LARAMIE COUNTY PLANNING & DEVELOPMENT DEPARTMENT

MEMORANDUM

TITLE: PUBLIC HEARING on a Subdivision Permit and Plat for Blue Roan Ranches, situated in all that portion East of I-25 R/W in the S½SE¼ of Section 27, Township 17 North, Range 67 West of the 6th P.M., Laramie County, WY.

PZ-23-00060 RED ROAN RANCHES II PDP
Preliminary Development Plan

LAND ANALYSIS
AND
PRELIMINARY
DEVELOPMENT
PLAN
FOR
RED ROAN
RANCHES II

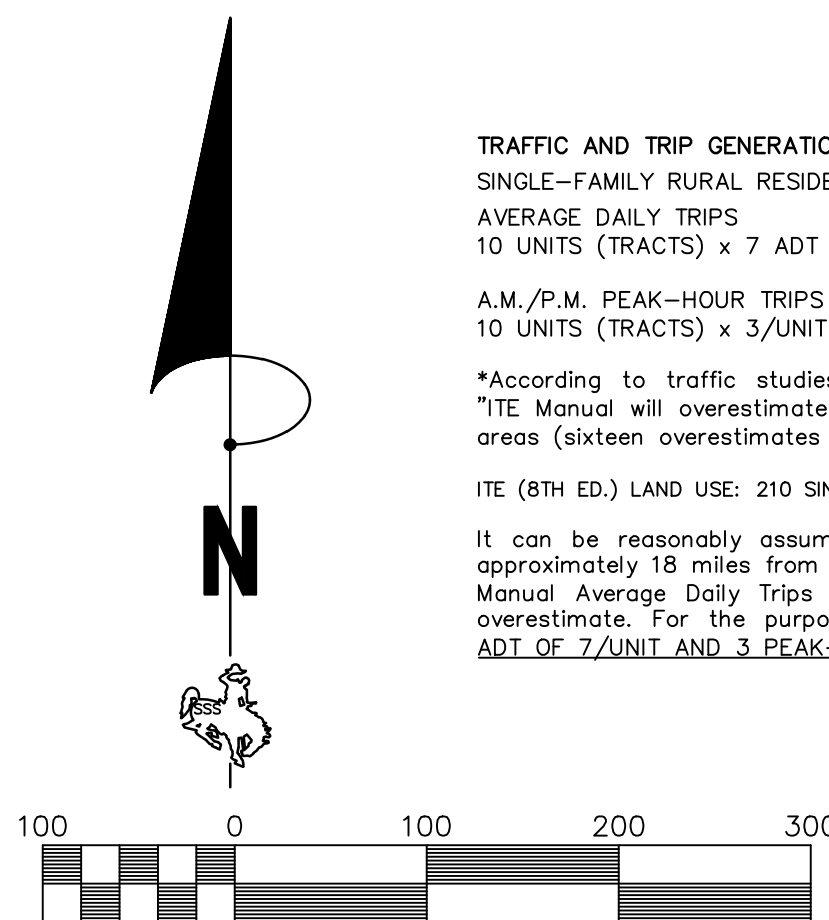
1. There is no curve data shown for C1 and C2. **ADDED TO FINAL**
2. All utilities (i.e., gas, power, etc.) shall be located underground per LCLUR. No waiver will be issued for above ground utilities. **AS DISCUSSED AT THE RED ROAN MEETING, THE DEVELOPER ALREADY HAS POWER PLANNED AS A COMBINATION OF ABOVE AND BELOW GROUND BASED ON AVAILABILITY OF MATERIALS FROM BHP&L**

3. I believe Roan Trail should be named Road 228 since it lines up and ties to it on the west side and it is on the section line. This should also be changed to dedicated ROW and not an easement. In addition, the ROW needs to be extended to the furthest eastern property line so that county road 228 can be extended for the potential for future developments to the east. By having it dedicated ROW, it will also allow others to the east to tie into the county road without issues related to easements. Drifter Lane can remain as an easement. **SEE FINAL PLAT**

1a. Roan trail shall be dedicated as an 80 foot right-of-way along the entire length of the plat boundary. The road shall be Road 228. **DEDICATED**

3. A note shall be added to the plat indicating maintenance of all roads will be done privately. **DEVELOPER IS REQUESTING COUNTY MAINTENANCE OF ROAD 228 AS THEY ARE BEING REQUIRE TO BUILD AN EXTRA 500 FEET OF ROAD. THEY WANT BUY IN FROM THE COUNTY**

6. The subdivision name shall be changed as this development is not adjacent to or a second filling of "Red Roan". **BLUE ROAN**

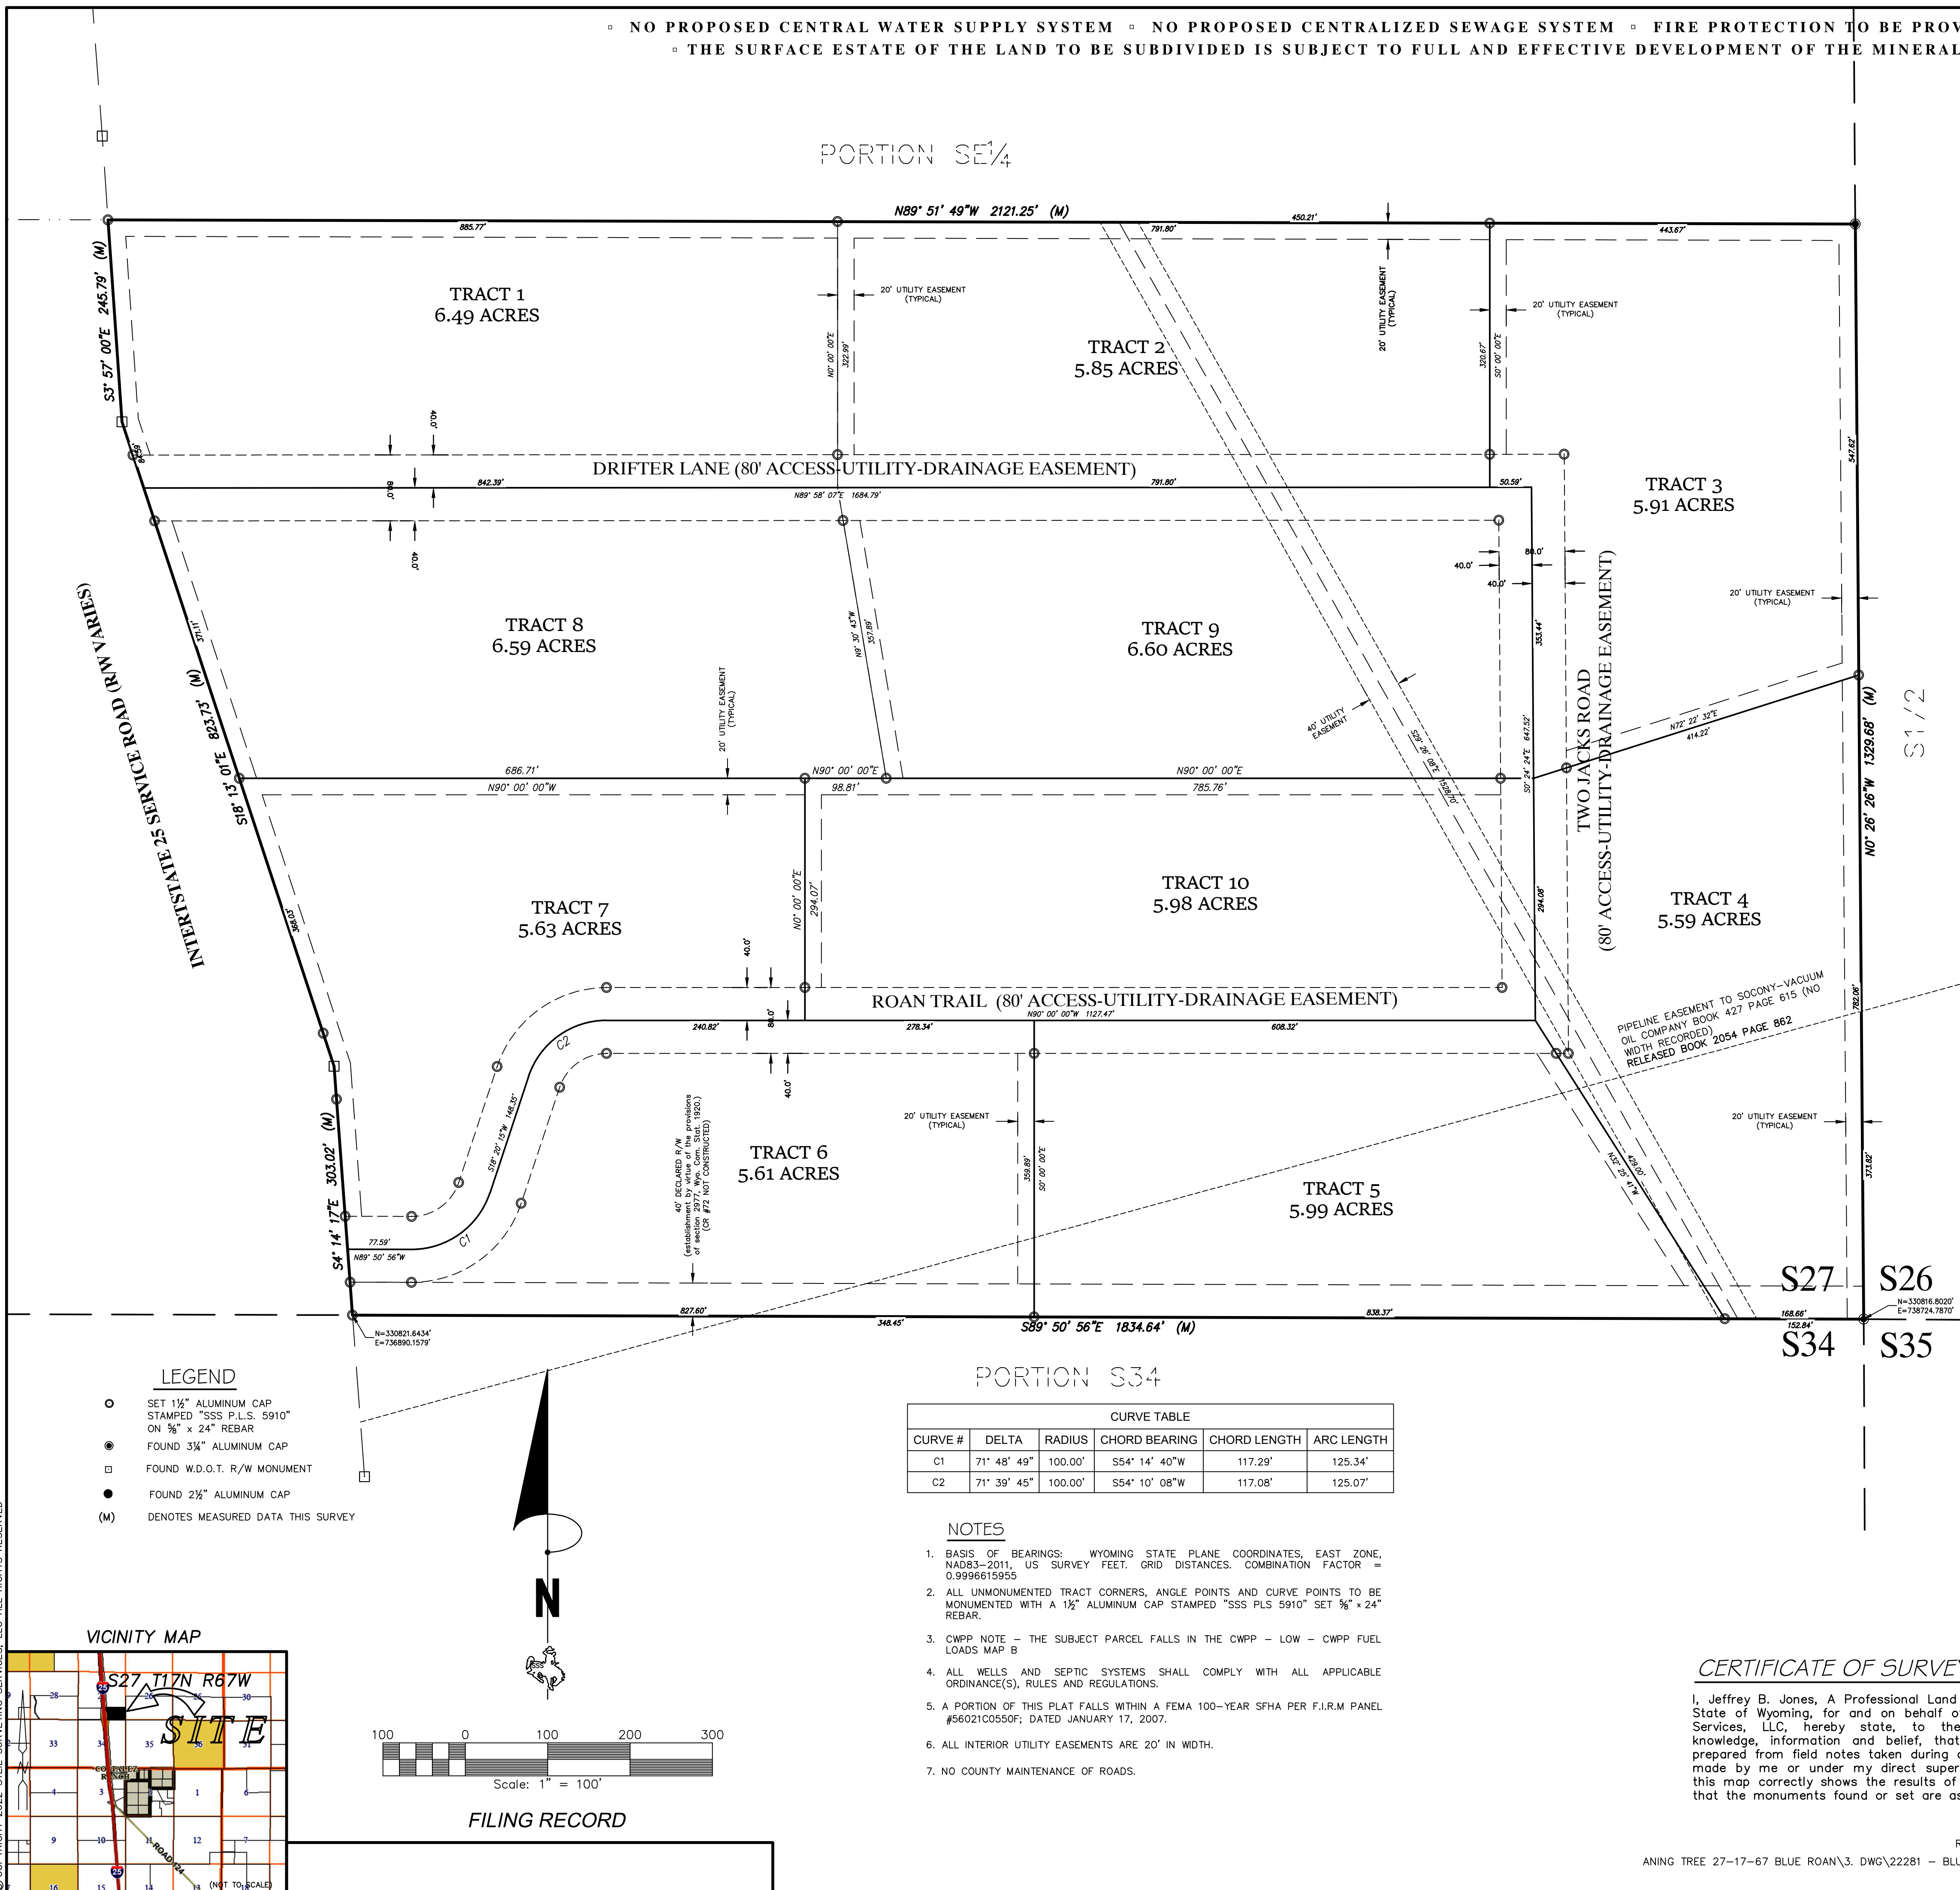
2. Under the Owner Acknowledgement and Approvals, the year is listed as 2022 and should be 2023. **CORRECTED**
3. There is no curve data for C1 and C2 shown on the plat. **ADDED**
